**NRC DISTRIBUTION FOR PART 50 DOCKET MATERIAL
(TEMPORARY FORM)**

Proposed amdt to OL/change to tech specs:
consisting of revisions to tech specs with
regard to safety limits for reactor thermal
power and power imbalance combination and
to flux-flow and power-imbalance trip set-
points...(40 cys encl rec'd)

Re: Oconee Nuclear Station
Docket Nos. 50-270, -287

This letter constitutes Duke Power Company's application for revision of the Oconee Nuclear Station Technical Specifications, pursuant to 10CFR50, §50.90. The proposed revision pertains to Oconee Units 2 and 3 and modifies (i) the safety limits for the reactor thermal power and power imbalance combination and (ii) the Reactor Protection System (RPS) flux-flow and power-imbalance trip setpoints.

Figure 2.3-2B

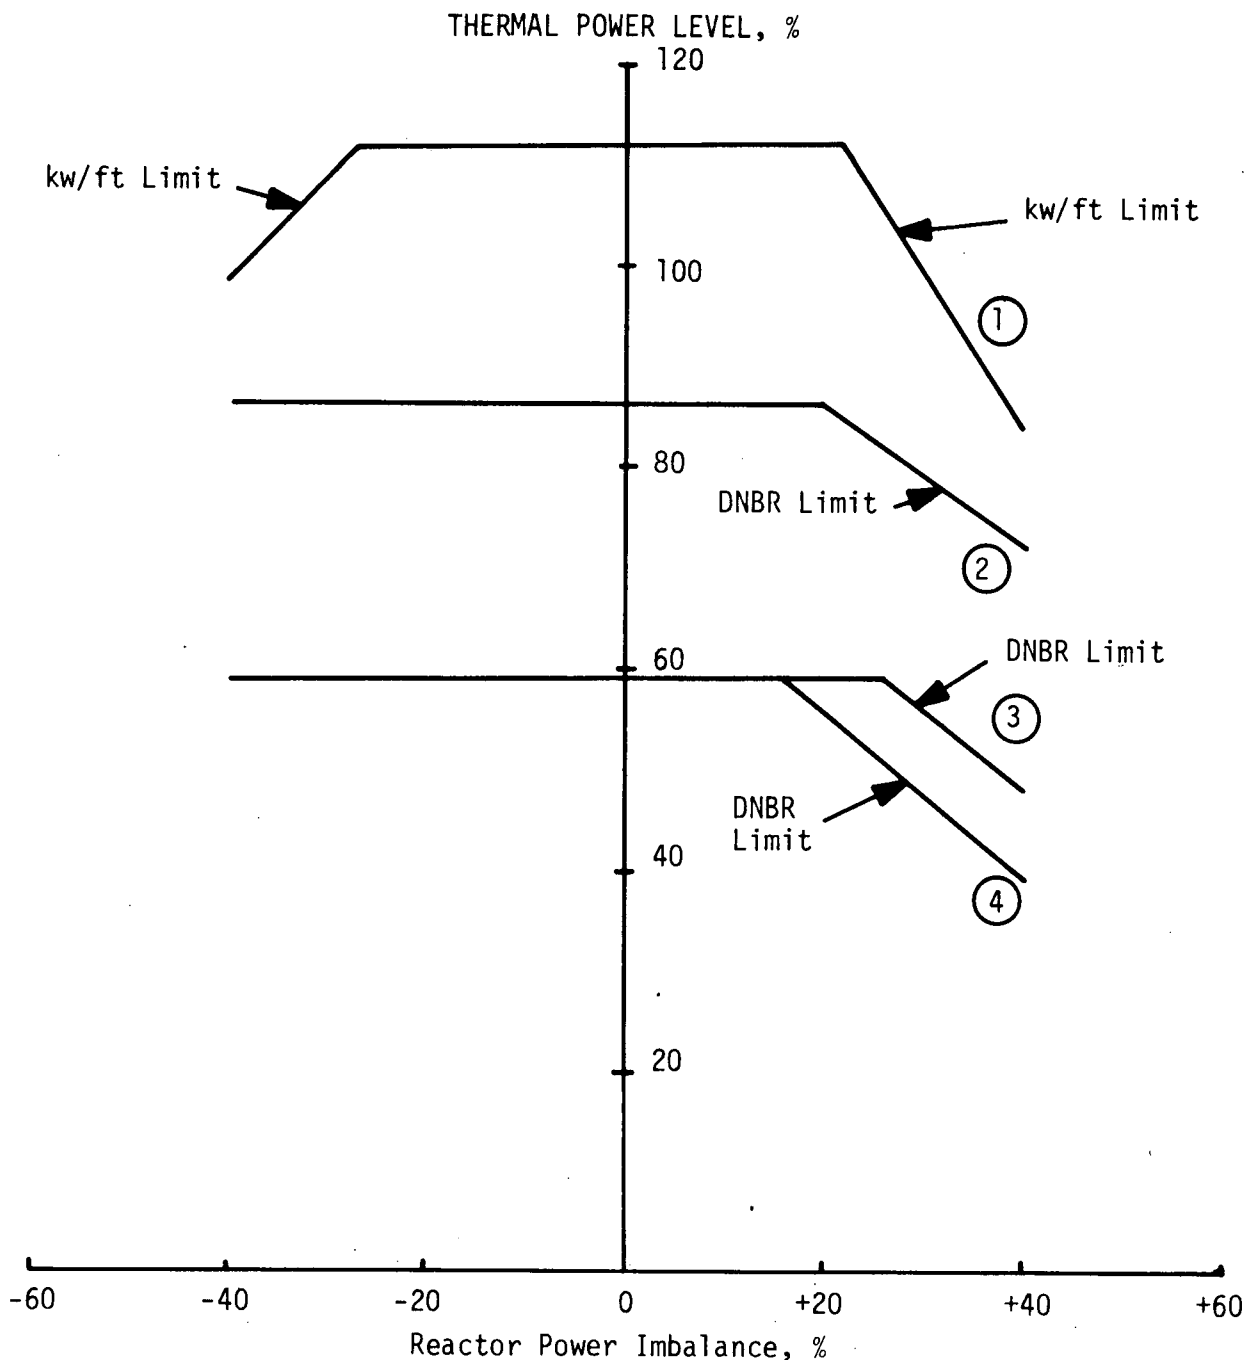
The proposed revision in imbalance limits necessitates a reduction of the flux/flow ratio from 1.07 to 0.961 for single loop operation in order to provide adequate margin from the revised imbalance safety limits.

For Units 2 and 3, the power-to-flow reduction factor is 0.961 during single loop operation.

Figure 2.3-2C

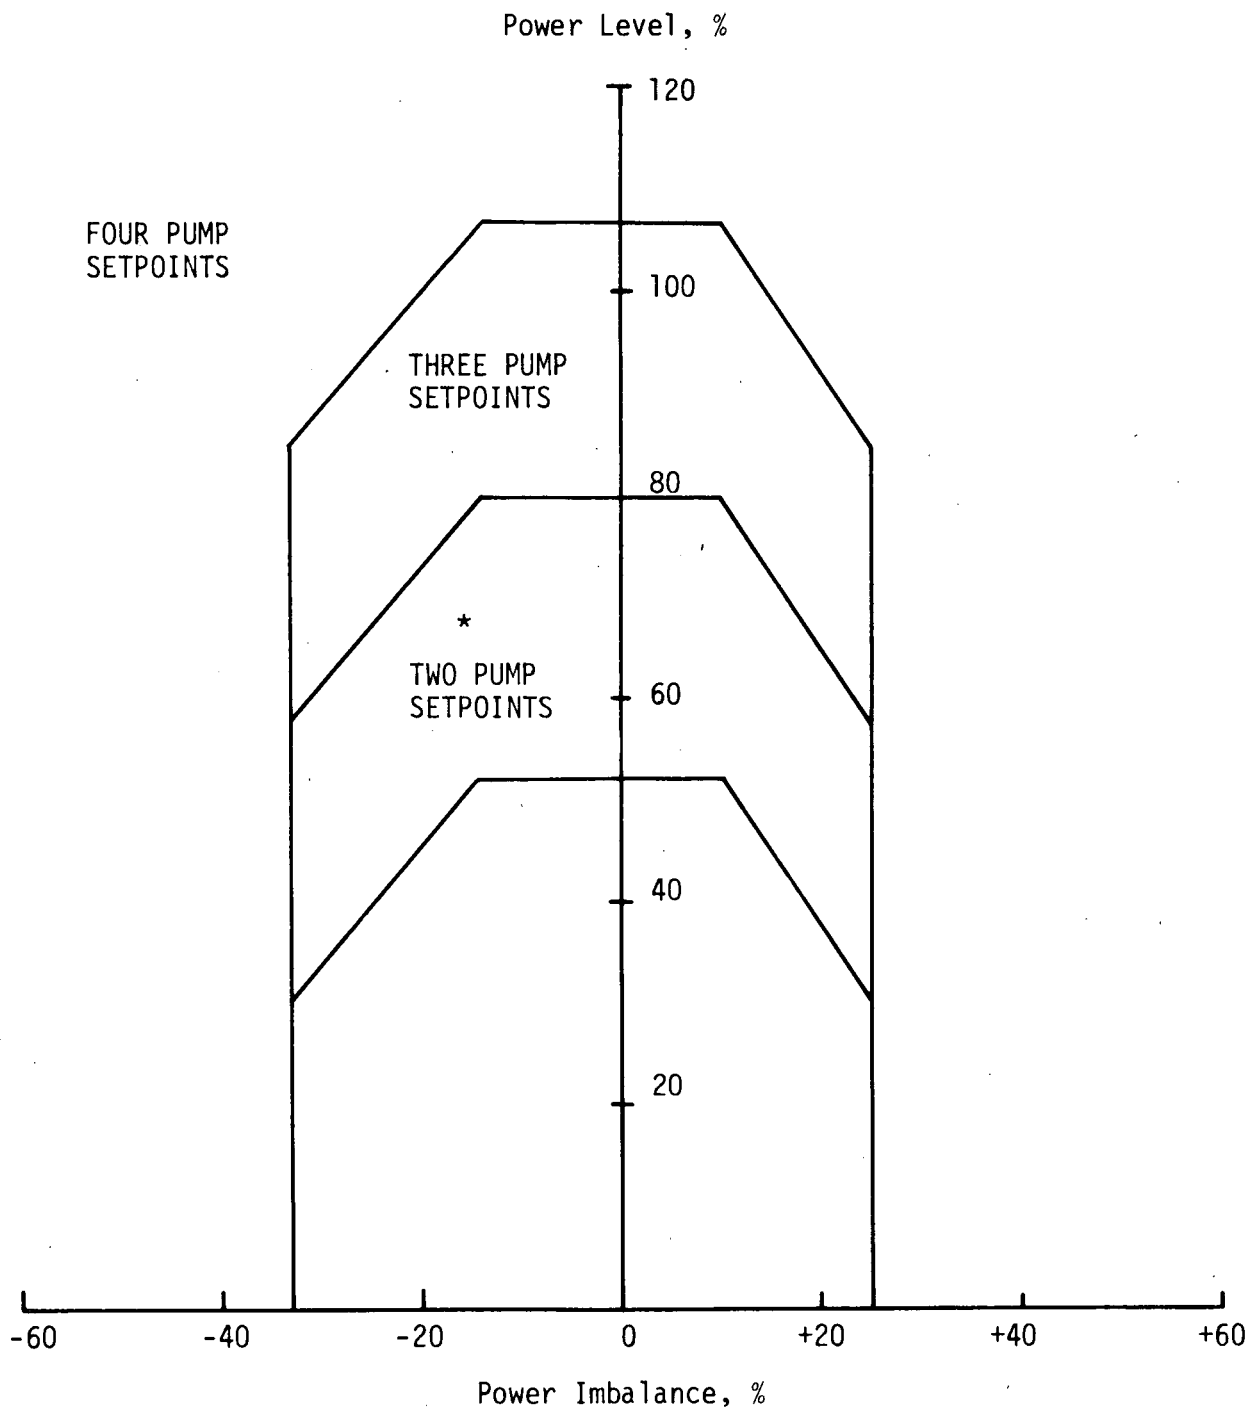
*For two pumps in one loop, the flux-flow setpoint must be 0.961

Figure 2.1-2B

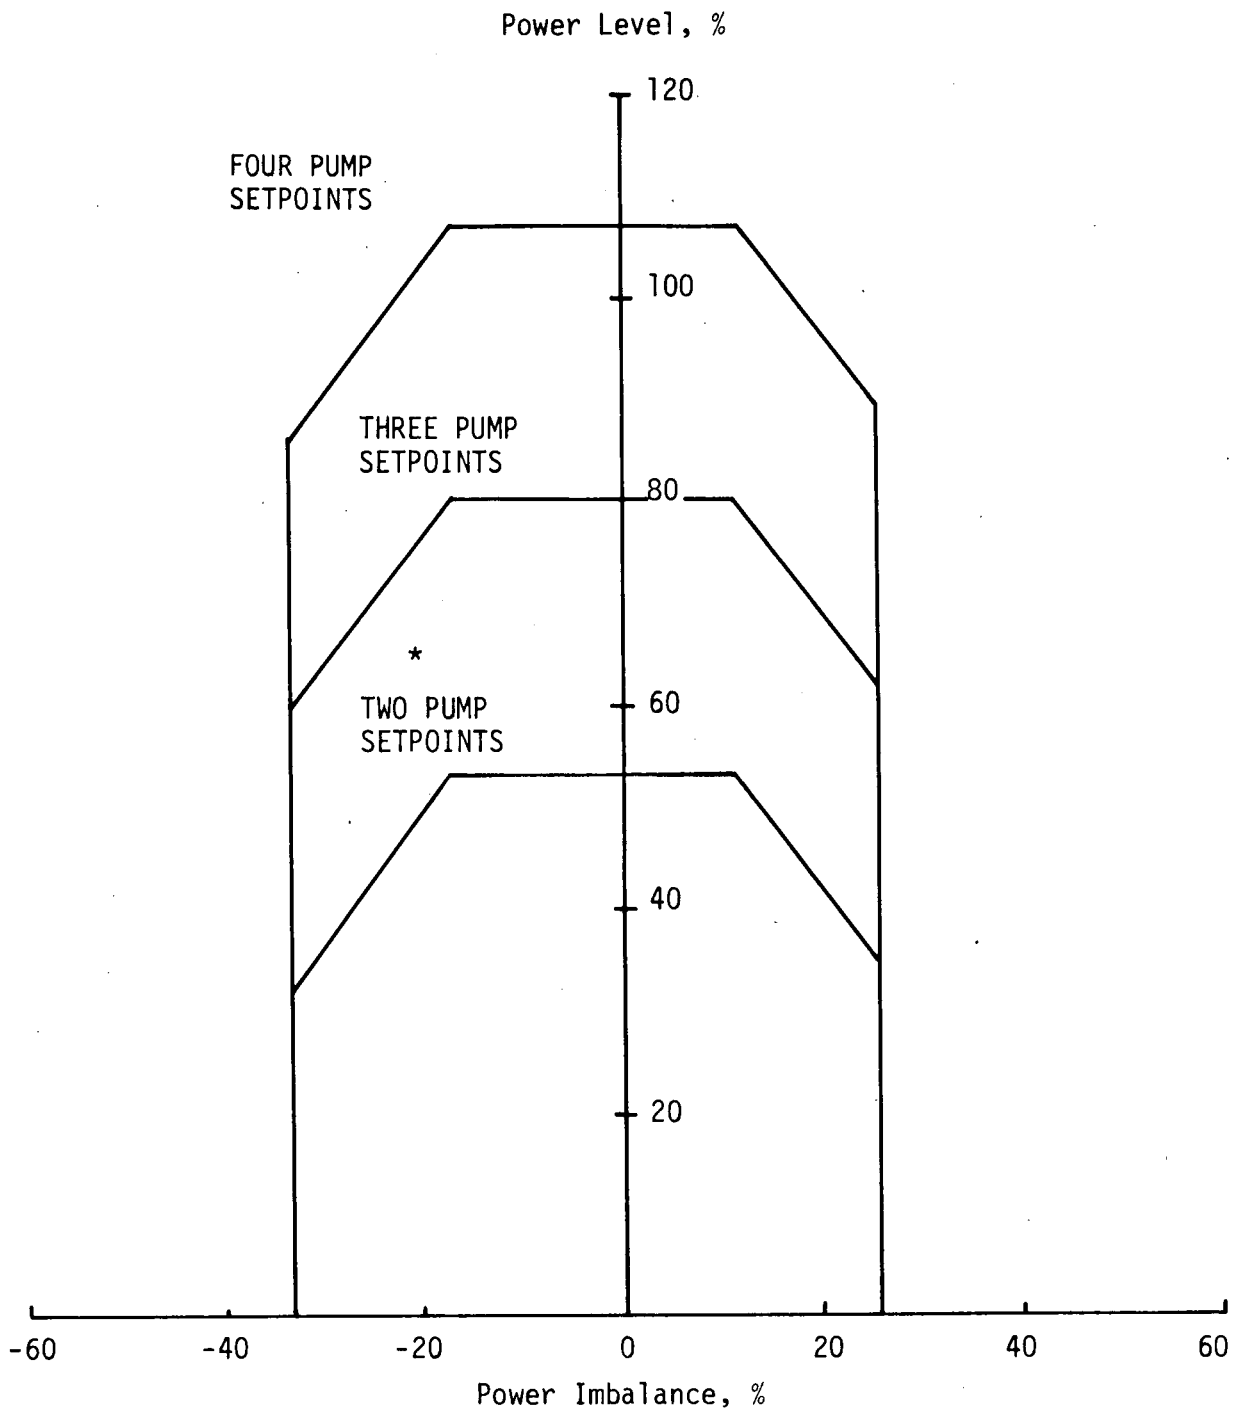
*For two pumps in one loop, the flux-flow setpoint must be 0.961.
